Date: JUN 07 2017
Symbol: EPC-DO: 17-196
LA-UR: 17-22189
Locates Action No.: N/A

Subject: Notification of Class 1 Permit Modification Facility Description Updates for the Technical Area 63 Transuranic Waste Facility Container Storage Unit, Los Alamos National Laboratory Hazardous Waste Facility Permit, EPA I.D. #NM0890010515 (NA/LA)

**Class 1 Permit Modification
Facility Description Updates for the
Technical Area 63 Transuranic Waste Facility
Container Storage Unit,
Los Alamos National Laboratory
Hazardous Waste Facility Permit**

Figure G.27-1, Transuranic Waste Facility Soil Sampling Grid

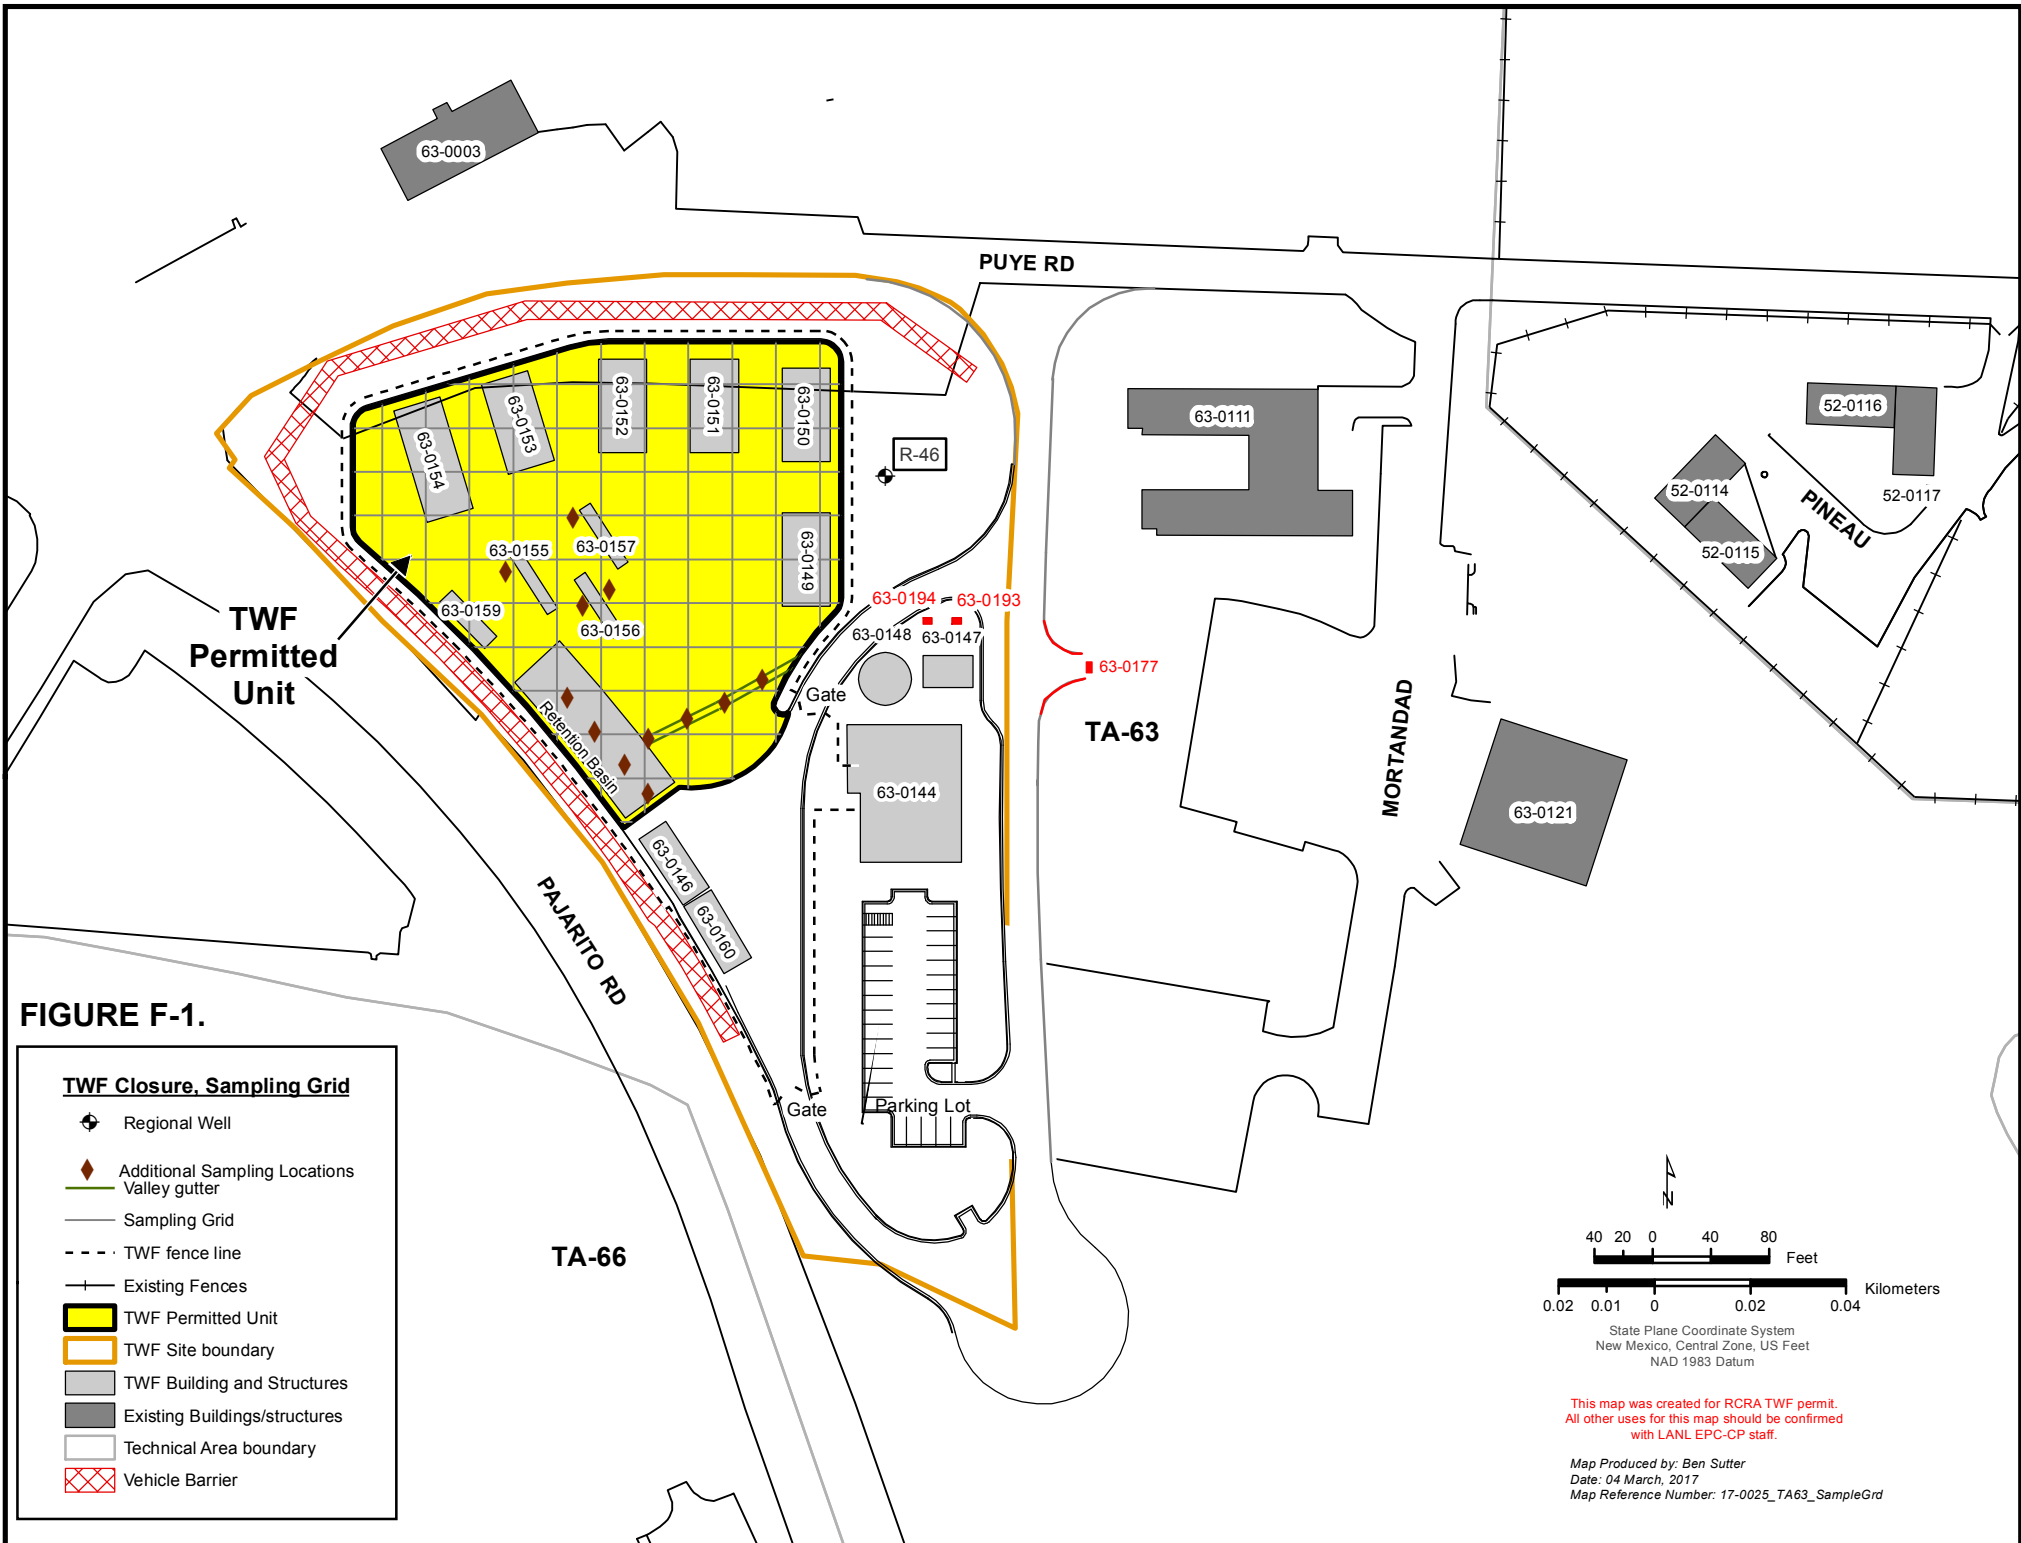
Permit Section A.6.6, *Other Project Structures*, Permit Figure 55, *Technical Area (TA) 63 Transuranic Waste Facility*, and Permit Figure G.27-1, *Transuranic Waste Facility Soil Sampling Grid*, have been revised to include descriptions and locations of two equipment structures associated with the TA-63 TWF. The two concrete structures are located north of TA-63-0144 (the Operations Support Building), are not within the permitted storage unit and are not used to manage hazardous waste containers. The structures are concrete enclosures for two seismic power cutoff systems. The seismic systems are control relays used to shut off power to the TA-63 TWF waste storage buildings and characterization trailers in the event of an earthquake to prevent potential electrical fires involving waste containers. A sentence has been added to Permit Section A.6.6 stating that two seismic power cutoff system enclosures are present north of the Operations Support Building. Figure 55 has been revised to provide the location of the concrete structures. Figure G.27-1 has been revised to show the location of the concrete structures and also to provide other changes updating the depiction of the surrounding area such as removed buildings, parking lots, and the facility vehicle barrier. Attachment 4 includes these revisions.
